ADA IMPROVEMENTS/ELEVATOR

**WESTERN MIDDLE SCHOOL
1 WESTERN JR HIGHWAY
GREENWICH, CT 06830
BID #2569-26**

S/P+A PROJECT #23.097

DATE: April 7, 2026

- DRAWING E213, WEST WING – GROUND FLOOR PLAN – POWER has been added and is attached as part of this addendum.* *(Per Owner Request)*

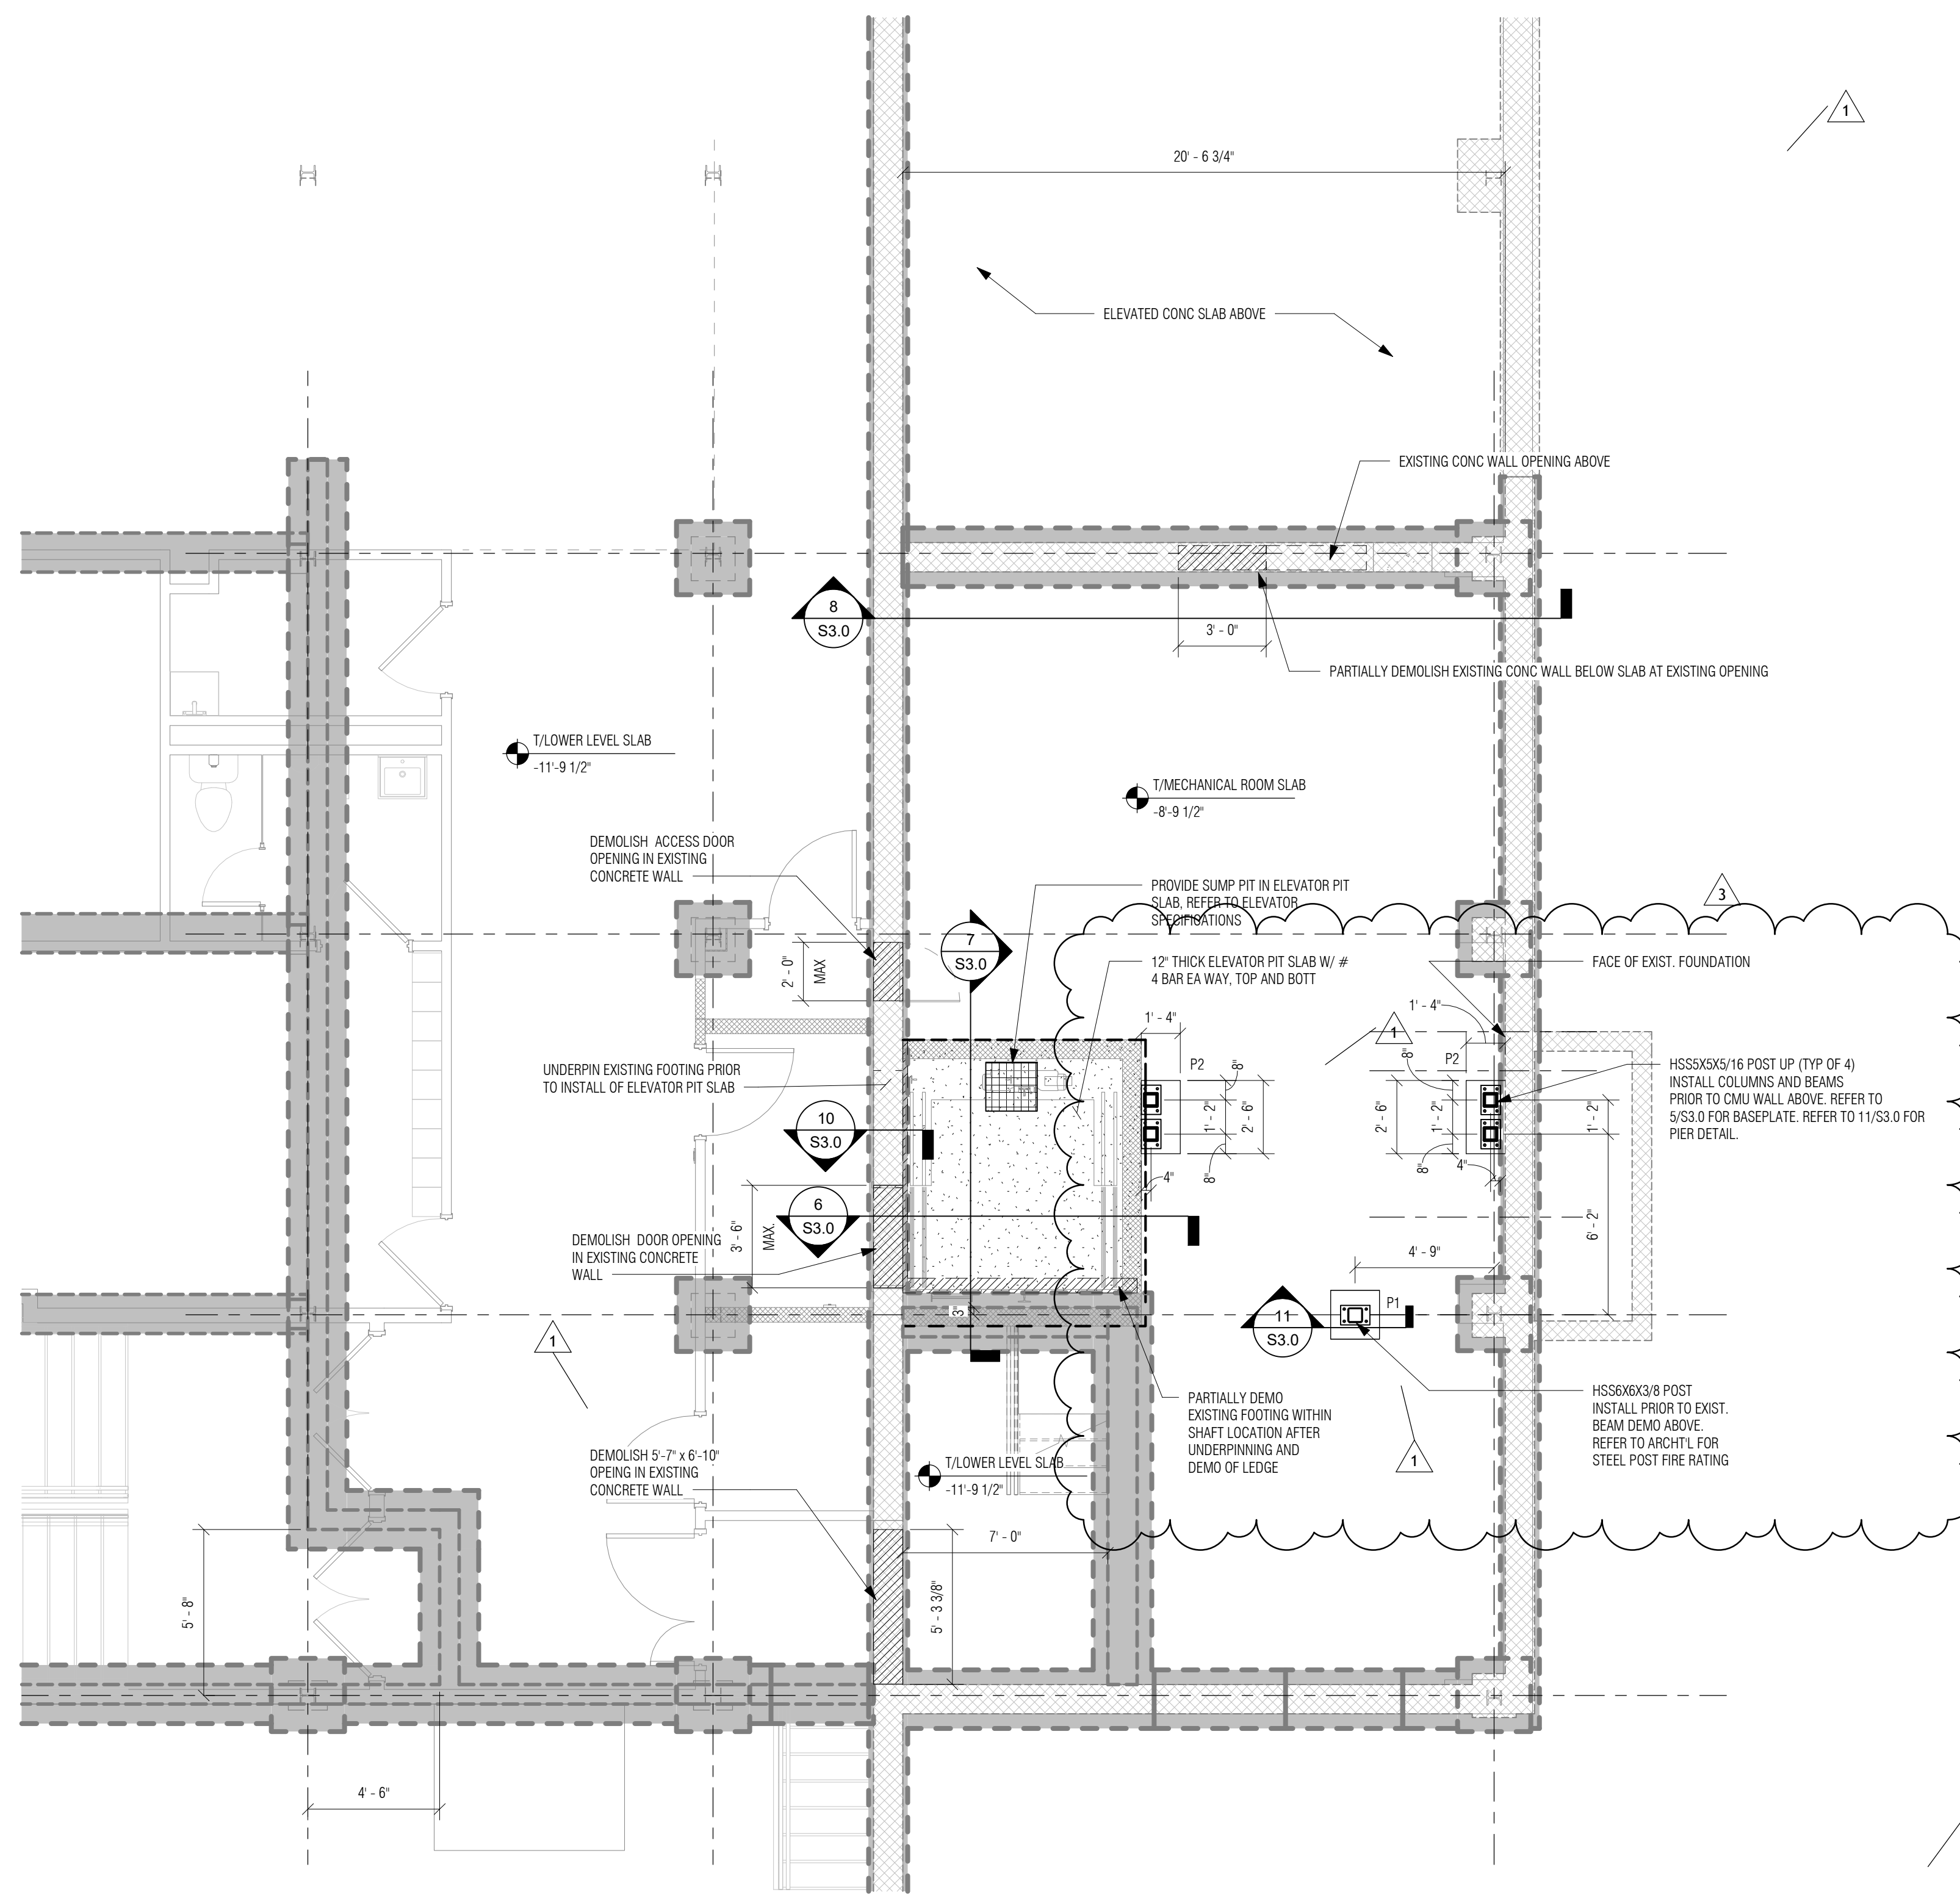
“E213 WEST WING – GROUND FLOOR PLAN – POWER”
 - Revise “E213” to read “E214”. *(Per Owner Request)*
